## HISTORIC AND DESIGN REVIEW COMMISSION

October 20, 2021

**HDRC CASE NO:** 2021-505  
**ADDRESS:** 515 MUNCEY  
**LEGAL DESCRIPTION:** NCB 1368 BLK 5 LOT 11  
**ZONING:** R-6, H  
**CITY COUNCIL DIST.:** 2  
**DISTRICT:** Dignowity Hill Historic District  
**APPLICANT:** Michelle Reyes  
**OWNER:** Michelle Reyes  
**TYPE OF WORK:** Exterior alterations, addition, window replacement, fenestration modifications, driveway modifications  
**APPLICATION RECEIVED:** September 30, 2021  
**60-DAY REVIEW:** Not applicable due to City Council Emergency Orders  
**CASE MANAGER:** Edward Hall

- SIDING TO BE REMOVED AND REPLACED BY #117 SIDING
- ROOF TO BE REPLACED BY HISTORICAL
- REFRAME EXISTING STRUCTURE TO 2018 IBC REQUIREMENTS
- REPLACE WINDOWS TO MEET HISTORICAL REQUIREMENTS.

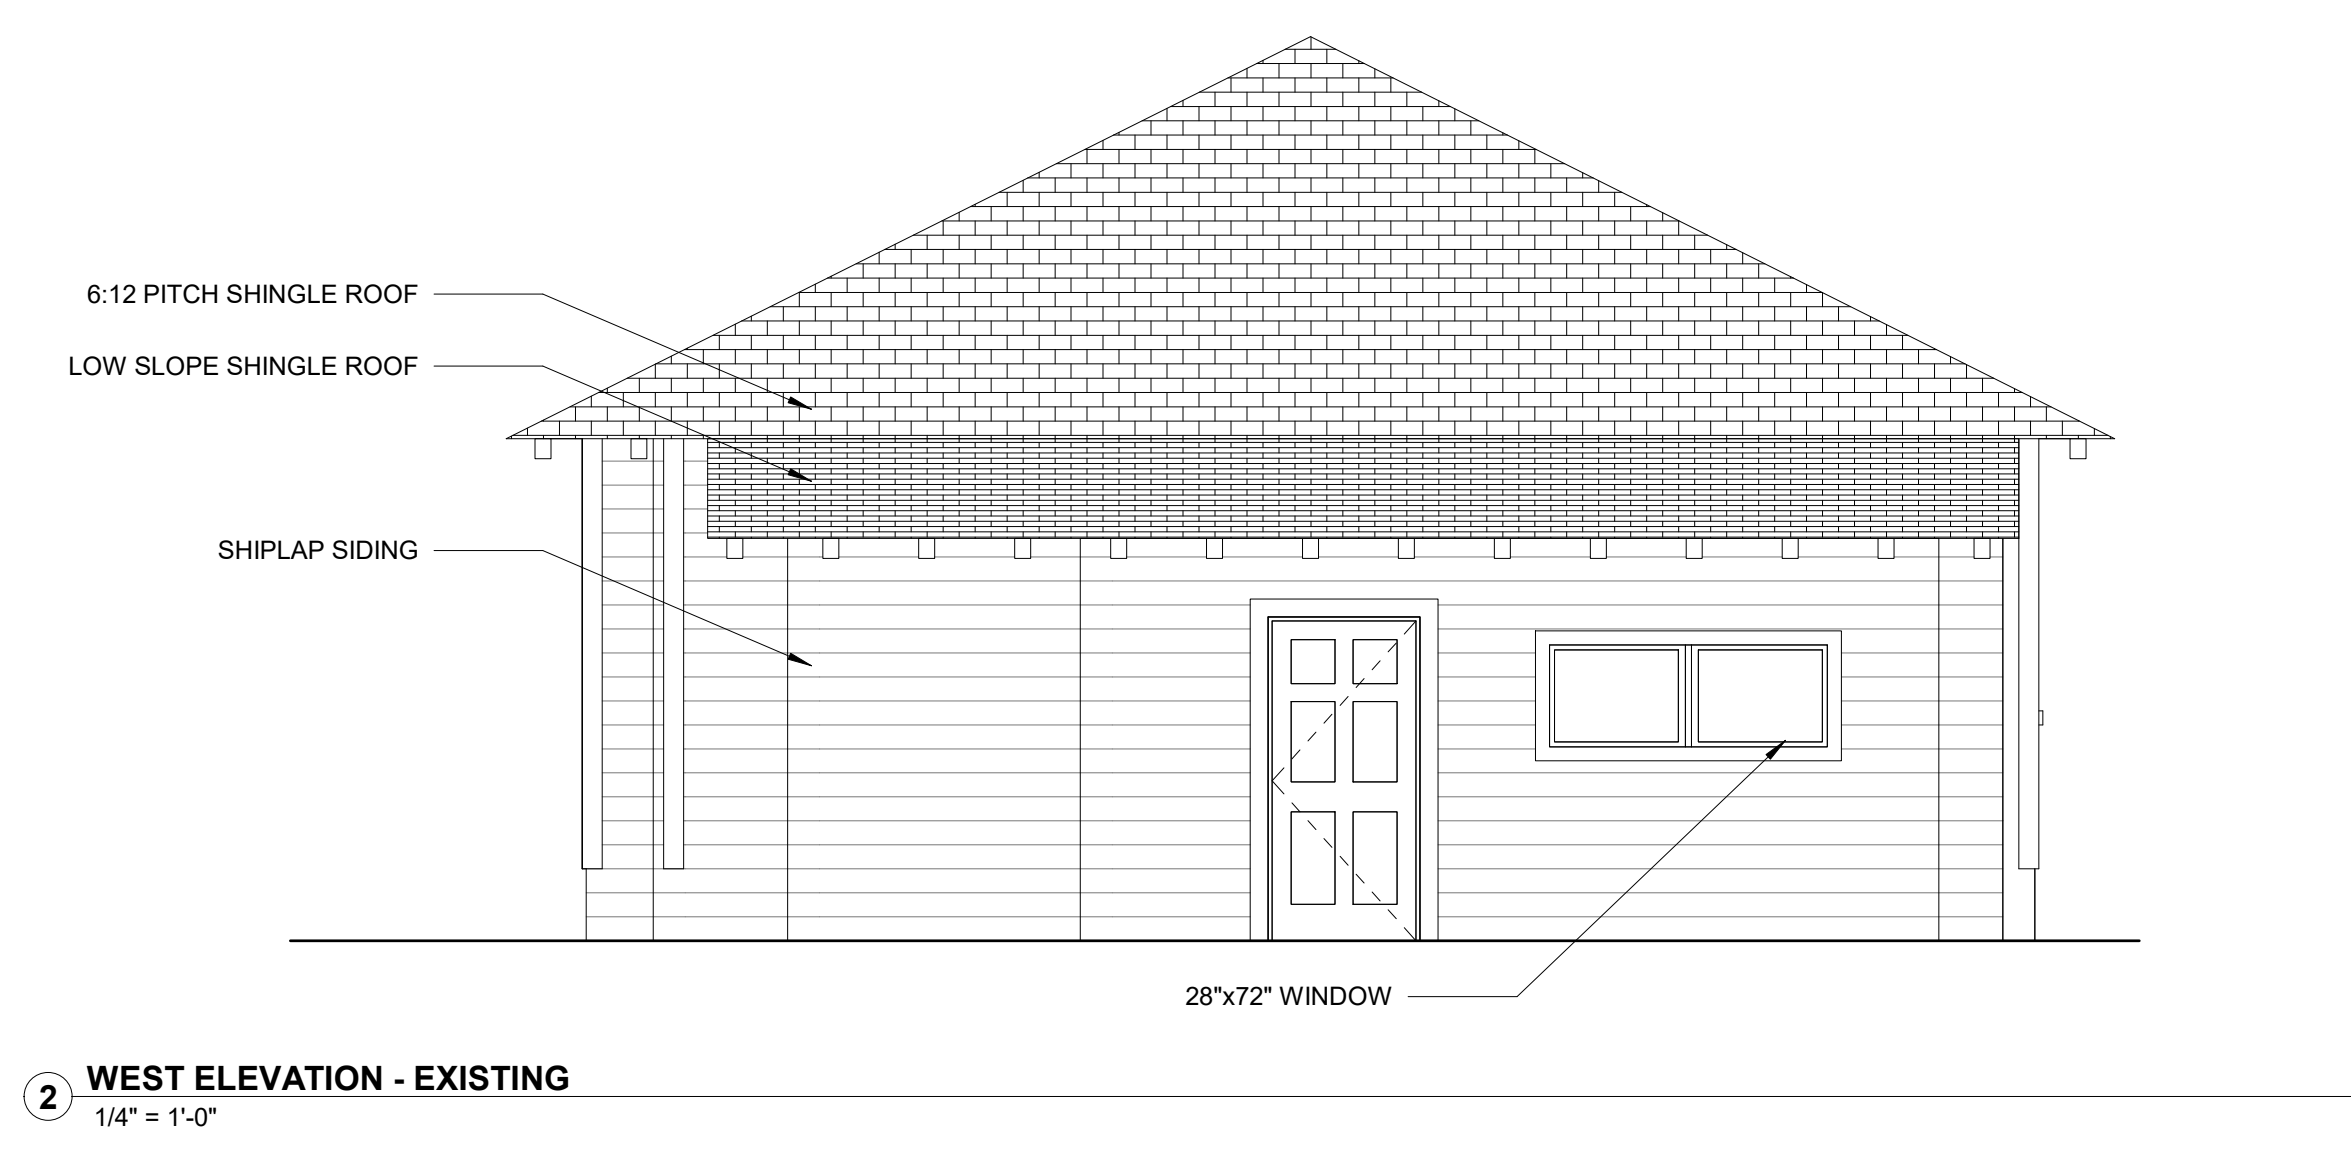
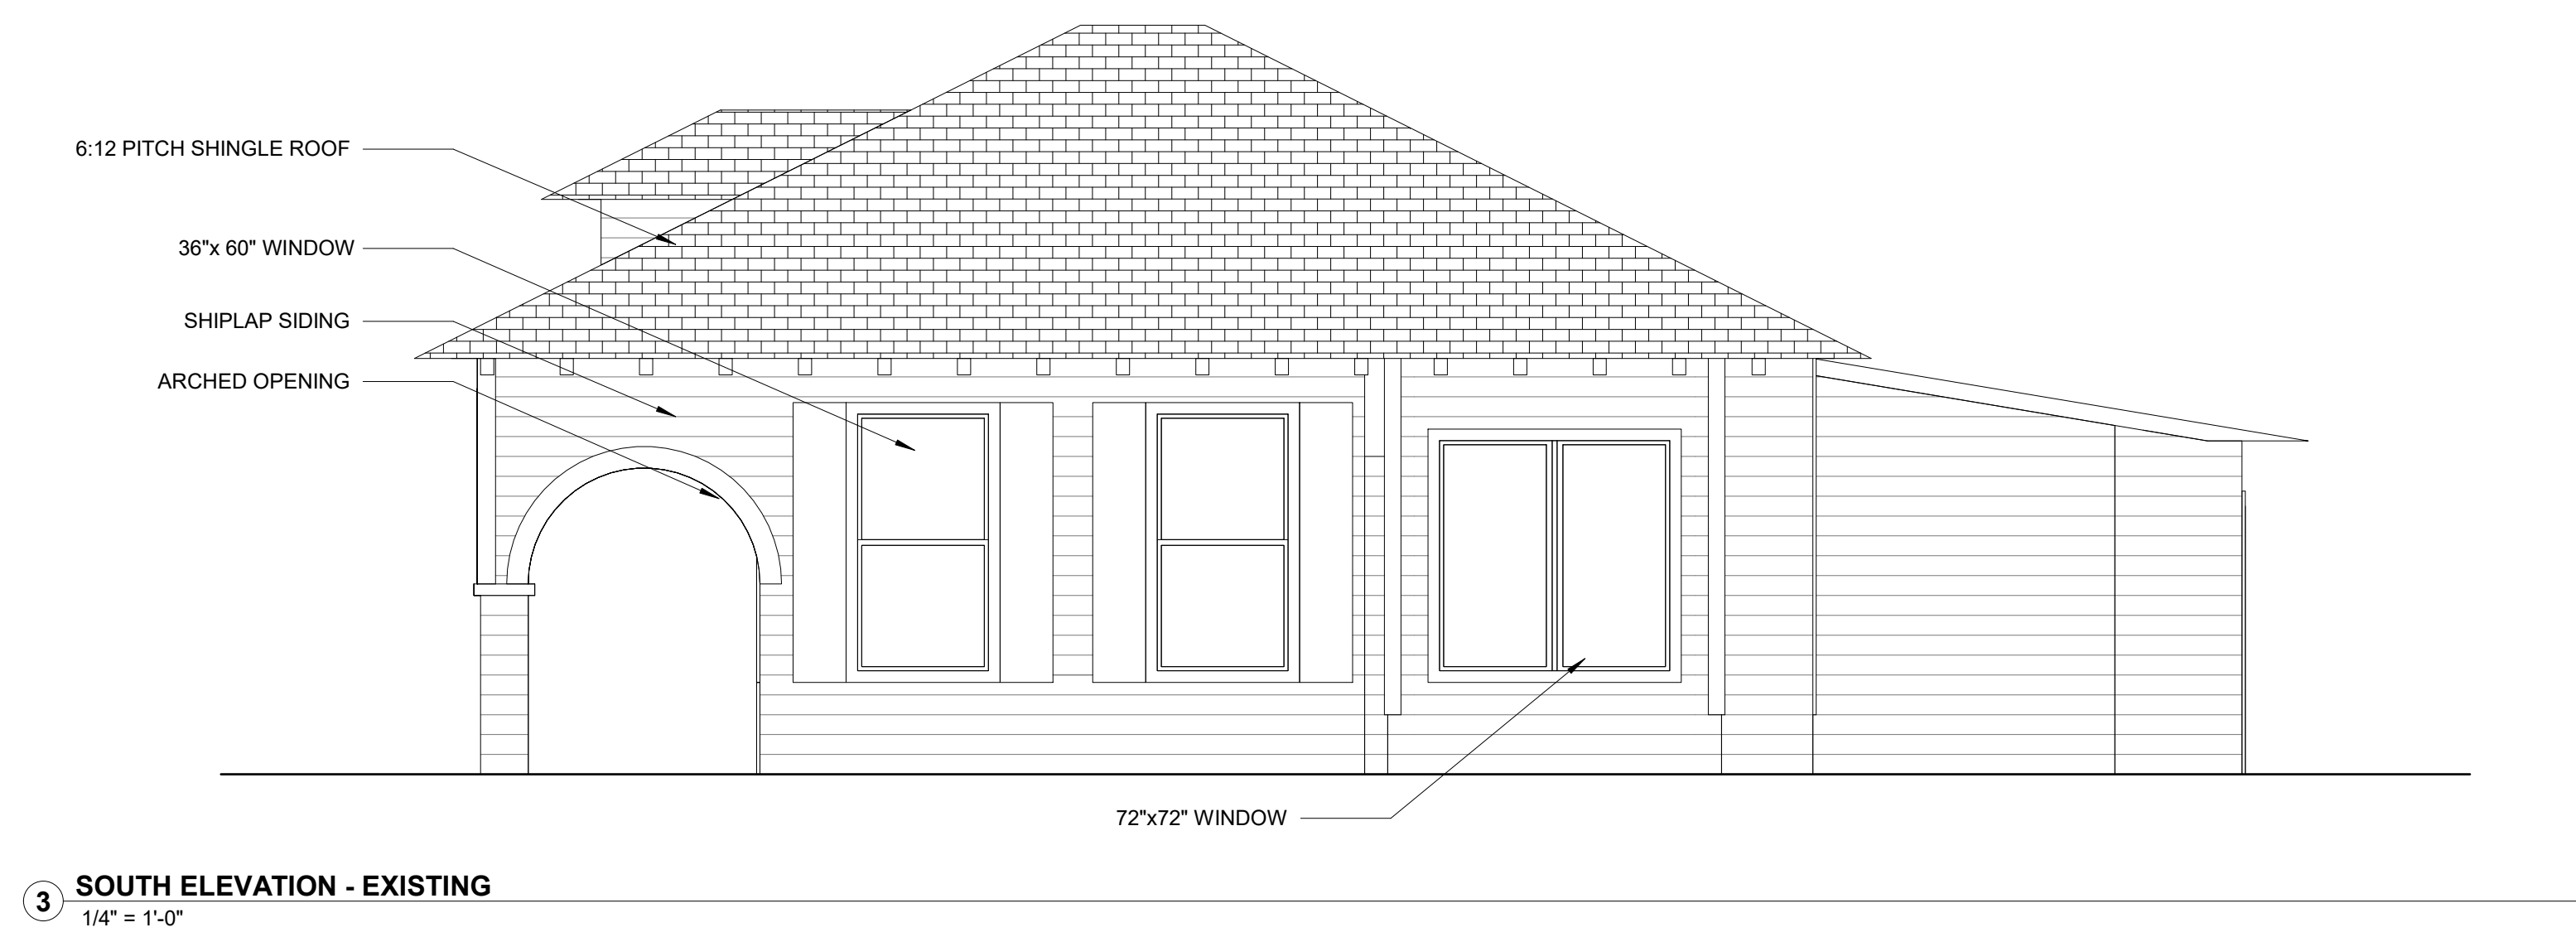
- c. SIDING – The applicant has proposed to replace the original wood siding with 117 profile siding. While the original wood siding had been covered by vinyl siding, portions that remain appear to be in good condition. Per the Guidelines for Exterior Maintenance and Alterations 1.B.i. materials that are in good condition should not be removed and should be repaired in place. Staff finds the replacement of the original siding to be neither consistent with the Guidelines not appropriate.

- d. WINDOW REPLACEMENT – The applicant has proposed to replace the existing wood windows with new windows. The applicant has not specified a specific window profile or material at this time. Pre-violation photos note one over one wood windows. Per the Guidelines for Exterior Maintenance and Alterations 6. A.iii. historic windows should be preserved. During staff’s site visit on September 2, 2021, all existing wood windows had been removed and discarded. Staff finds that salvaged or custom fabricated, one over one wood windows should be installed to match the original in size and profile.

- f. FENESTRATION MODIFICATIONS – The applicant has proposed fenestration modifications including the removal of a window on the front façade, and modifications to openings on the sides (north and south facades), including the expansion, shifting and removal of original window openings. The Guidelines for Exterior Maintenance and Alterations 6.A.i. notes that existing window and door openings should be preserved. Staff finds the applicant’s request to modify the original window openings to be inconsistent with the Guidelines.

- g. FRONT DOOR REPOSITIONING – The applicant has proposed to reposition the front door to be centered on the front façade. The existing door opening is off-centered, positioned to the right of the center of the structure. The Guidelines for Exterior Maintenance and Alterations 6.A.i. notes that existing window and door openings should be preserved. Staff finds the applicant’s request to modify the original window openings to be inconsistent with the Guidelines. Staff has found no evidence that this door opening is not the original. Staff finds the proposal to reposition the door to be inconsistent with the Guidelines.

- 1. Staff does not recommend approval of item #1, the replacement of the original wood siding, based on finding c. Since all original siding has been removed and discarded, staff recommends that siding that features a matching profile be installed.

- 2. Staff does not recommend approval of item #2, the replacement of all original wood windows, based on finding d. Since all original windows have been discarded, staff recommends that salvaged or custom fabricated, one over one wood windows be installed to match the original in size and profile.

- 4. Staff does not recommend approval of item #4, fenestration modifications. Staff recommends that all original window openings should be restored and that no new openings should be introduced to the historic structure, based on finding f.

- 5. Staff does not recommend approval of item #5, front door repositioning, based on finding g. Staff recommends that the existing door opening be preserved.

NEW ELEVATIONS

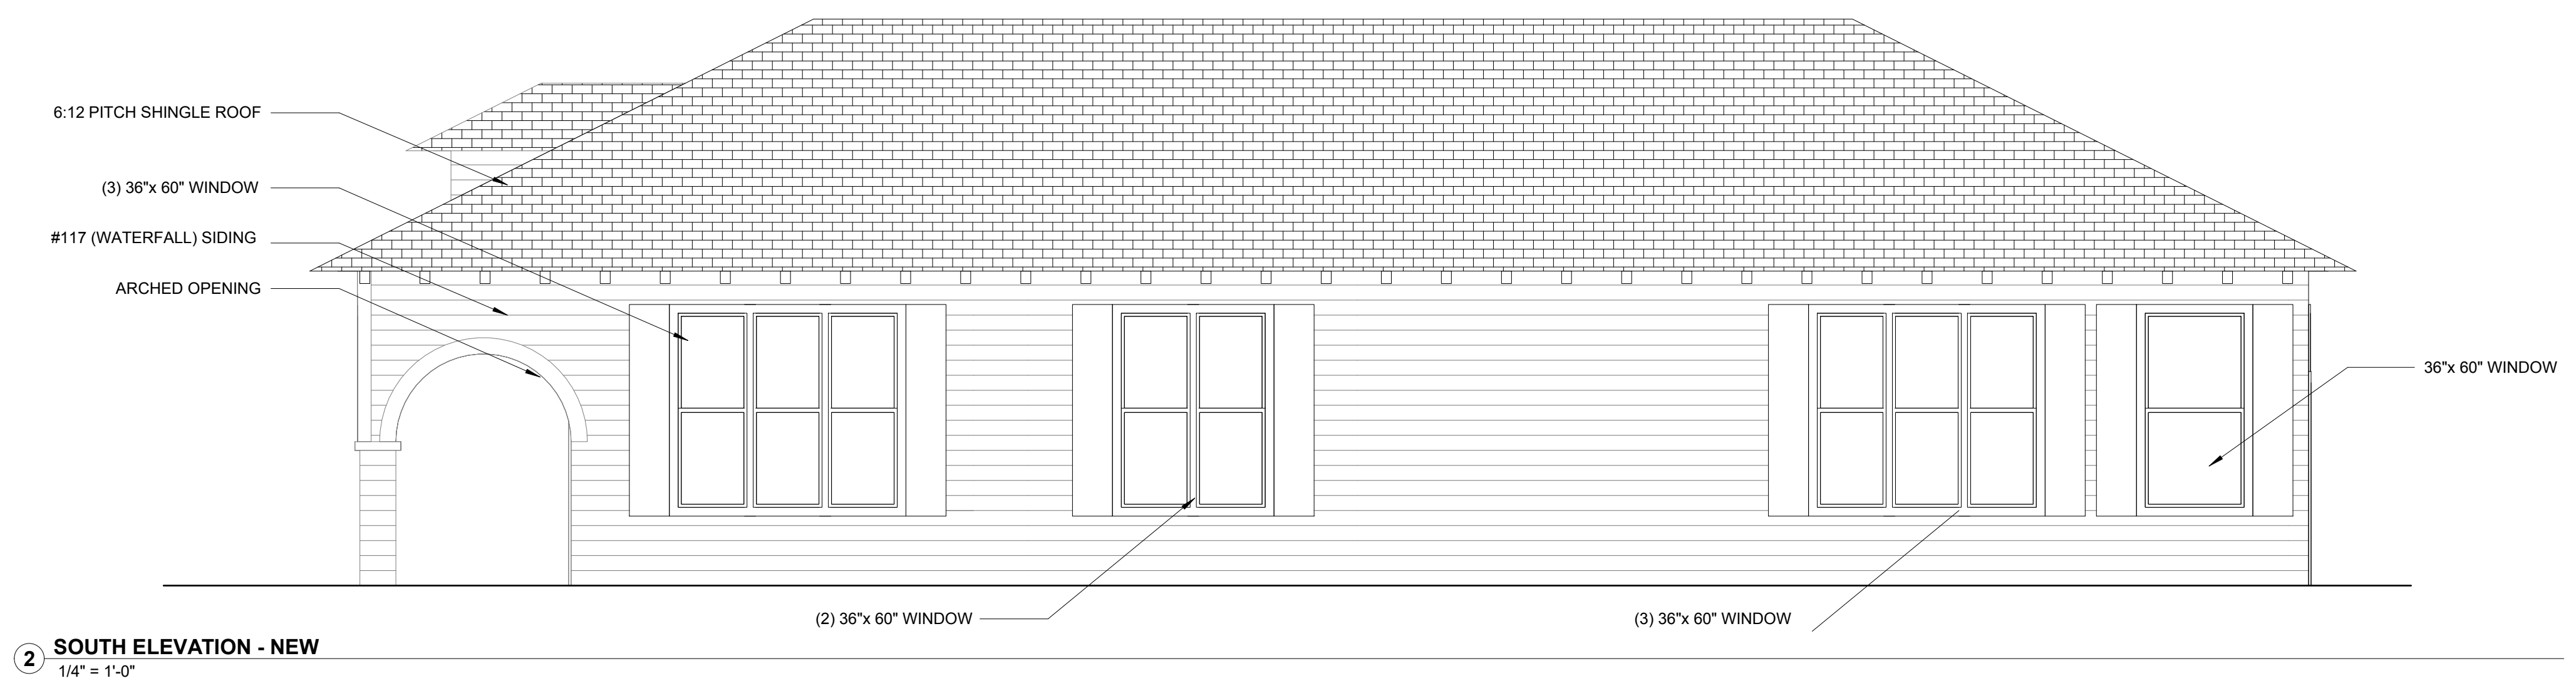
- i. REAR ADDITION – The applicant has proposed to construct a rear addition. The Guidelines for Additions 1.A. notes that additions should be sited to minimize view from the public right of way, should be designed to be in keeping with the existing, historic context of the block, should feature similar roof forms, and should feature a transition to differentiate the new addition from the historic structure. Additionally, the Guidelines for Additions 1.B notes that additions should be subordinate to the principal façade of the historic structure, should feature a

footprint that responds to the size of the lot, and should feature an overall height that is generally consistent with that of the historic structure. Generally, staff finds that the proposed addition should feature insets on each wall plane and a roof that is subordinate to that of the original structure to differentiate between the addition and the historic structure and to preserve the historic structure's roof form. Given the lot's size, staff finds that an addition that is larger than recommended by the Guidelines may be appropriate provided that the previously noted design elements are modified.

- k. REAR ADDITION (Architectural details) – As noted in finding i, staff finds that the proposed addition should feature insets on each wall plane and a roof that is subordinate to that of the original structure to differentiate between the addition and the historic structure and to preserve the historic structure's roof form. Additionally, staff finds that the proposed exposed rafter tails should be simplified in design as to not be an exact copy of those found on the historic structure.

- 6. Staff recommends approval of item #6, the construction of a rear addition with the following stipulations:
  - i. That the proposed addition should feature insets on each wall plane and a roof that is subordinate to that of the original structure to differentiate between the addition and the historic structure and to preserve the historic structure's roof form.

- ii. That the addition feature wood or aluminum clad wood windows that are consistent with staff's standards for windows in new construction and additions.

- iii. That the proposed exposed rafter tails should be simplified in design as to not be an exact copy of those found on the historic structure.
  - iv. That all grouped windows be separated by a mullion of at least six (6) inches in width.
